## Matrix of Public Submissions and Proponent Response

The following table provides a response to all of the matters raised from members of the public during the public exhibition of D/2015/1049/ SSD 15\_7101. In summary, the following issues are addressed:

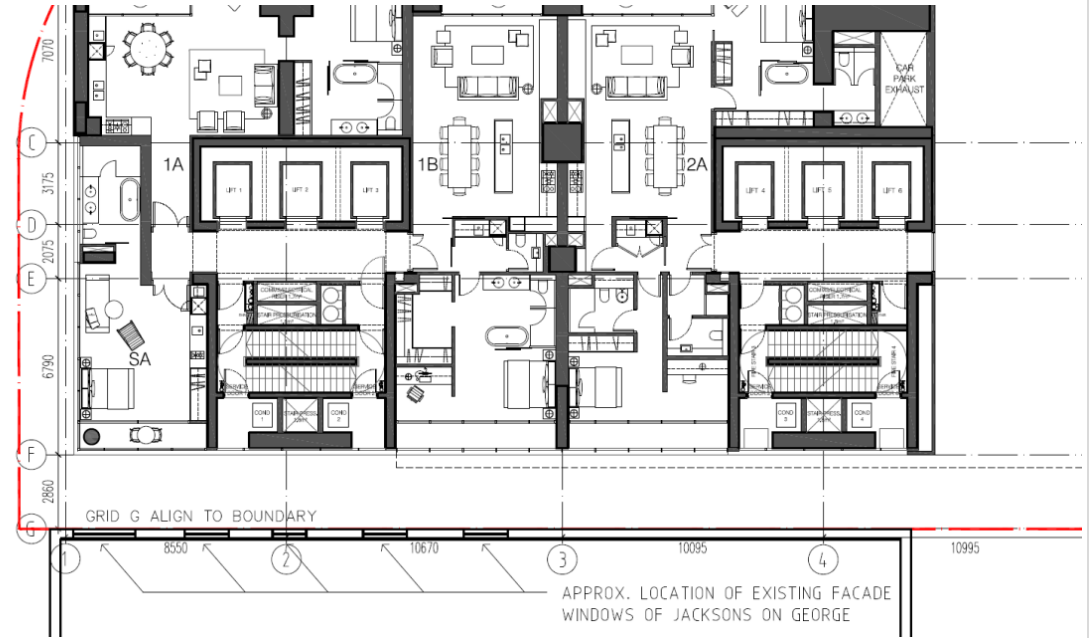
- Jacksons on George currently has an open terrace at its upper most level adjacent to George Street. The proposed southern façade extension and introduction of residential balcony uses to the southern façade of Tower A under D/2015/882 between levels 7 and 38 is not supported because residential balconies directly adjacent an operating hotel venue with a 24 hour, 7 day licence and open terrace entertaining areas will likely lead to conflict with the future strata owners of 1 Alfred Street Tower A apartments, because of noise complaints. The Wanda application provides inadequate baseline data to assess the risks associated with potential noise and vibration from the Jacksons on George open roof terrace. The Wanda application does not adequately address how these risks will be avoided, minimised, offset, nor detailed contingency planning.

- As such, the proposed southern balconies between levels 7 and 38 under Amending DA 2015\_882 proposal are deleted and the southern façade treatments previously approved under D/2010/2029 be reinstated.

- The southern residential façade line of Tower A should be upgraded to ensure that its ‘as constructed’ acoustic performance and rating are of such a performance standard that it ensures future residential apartment owners are adequately acoustically protected from the Jacksons on George premises and its acoustic emissions such that their “quiet enjoyment” will be retained at all times over the 24/7 operating cycle of Jacksons on George (including the roof terrace).

- The proposed balconies are likely to be problematic in both the short and longer term because noise emitted from existing plant and equipment arrangements at Jacksons on George is more likely to reach and impact upon sensitive residential apartment receptors via balconies above. The Wanda application provides inadequate baseline data to assess the risks associated with potential noise and vibration from Jacksons on George plant and equipment and does not assess cumulative impacts. The Wanda application does not adequately address how these risks will be avoided, minimised, offset, nor detailed contingency planning.

- As acknowledged in their submission, Jacksons on George must comply with the City of Sydney acoustic guidelines. Considering the current use of the site is for commercial purposes, given the acoustic requirements for impact on commercial properties, there should be no significant impact on the development, even taking into account the proposed change to residential and hotel uses.

- Further, the proposed bedrooms in the development are already proposed to have 10.38mm laminated glass, given the CBD location of the site, and as such Jacksons on George would have to produce unreasonably and extraordinarily loud volumes for this glazing to be insufficient.

- Finally, the introduction of small, secondary balconies on the southern site boundary should not impact the quiet enjoyment of the residential units internally. The introduction of balconies to this façade would provide a buffer for these residential units, compared to that approved. Notably all bedrooms adjacent to the southern boundary at Levels 3 – 5 are now further from Jacksons on George Noise sources, as a result of the inclusion of balconies, than they were at Level 4 and Level 5 of the approved scheme.

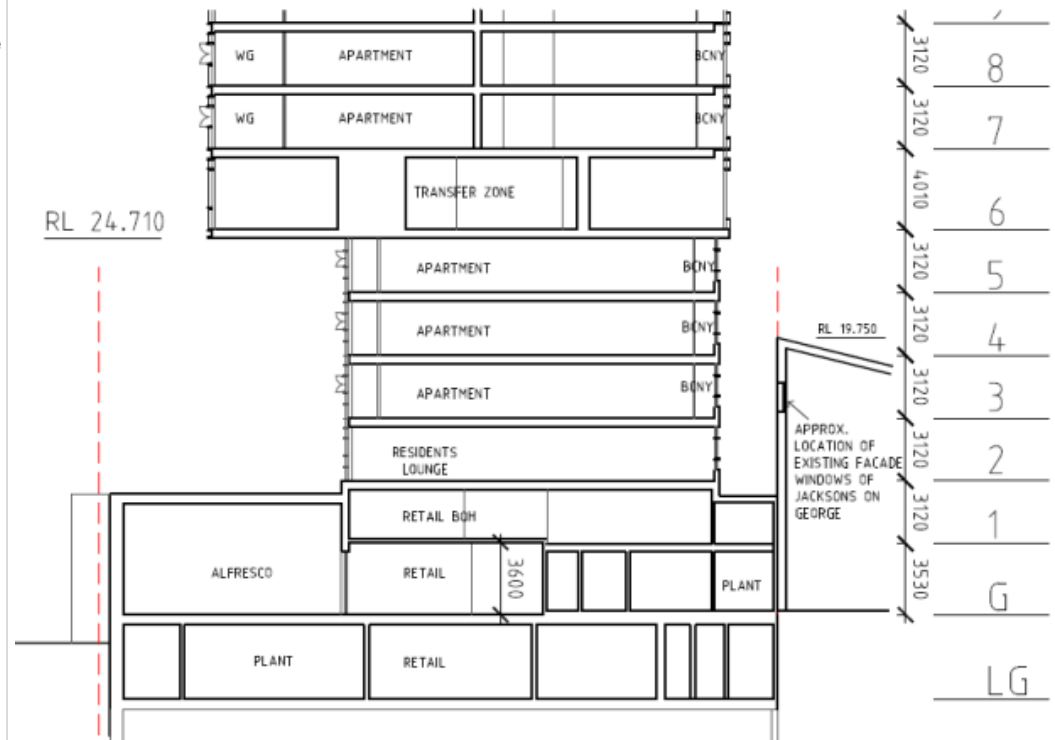
- Jacksons on George has a number of existing, approved, and operable windows along its northern façade. The proposal has the potential to create a nuisance lighting issue to residential apartment owners and occupants arising from the extended operating hours and internal feature lighting within Jacksons on George.

- JLL recommends that a condition of development consent be imposed upon Wanda requiring the Kerry Hill southern façade design be amended at the lower levels to provide for permanent façade nuisance light screening in the cases where intensification of high end apartment occupants below and above circa level 7 (under the Wanda proposal) have the potential to be impacted by nuisance lighting from within the upper level of Jacksons on George during extended operating hours (including late night/predawn early morning).

- The image above illustrates that due to the position of the existing Jacksons on George windows there is no concern for unit type 2A at these levels. Unit type SA has a winter garden proposed at the southern boundary and as such is further setback from any potential noise and light sources. Further, this unit has a dual orientation, primarily to the west and as such passive mitigation measures (i.e. blinds or screens) can be implemented to ensure amenity of this unit from operations at Jacksons on George. Unit types 1B and 2A however will have one window adjacent to the southern façade; and as such mitigation measures will be required for this one unit. This is addressed within Section 14 in this Response to Submissions Table.

- The windows of Jacksons on George have a negligible impact on the proposed Tower A. The position of the windows, as documented on the Council approved plans for Jacksons on George, only affects apartment types SA and 1B on Level 3 (as described above). The proposed southern winter garden to unit SA forms a buffer against the foremost light nuisance and is inconsequential when considering the dual aspect
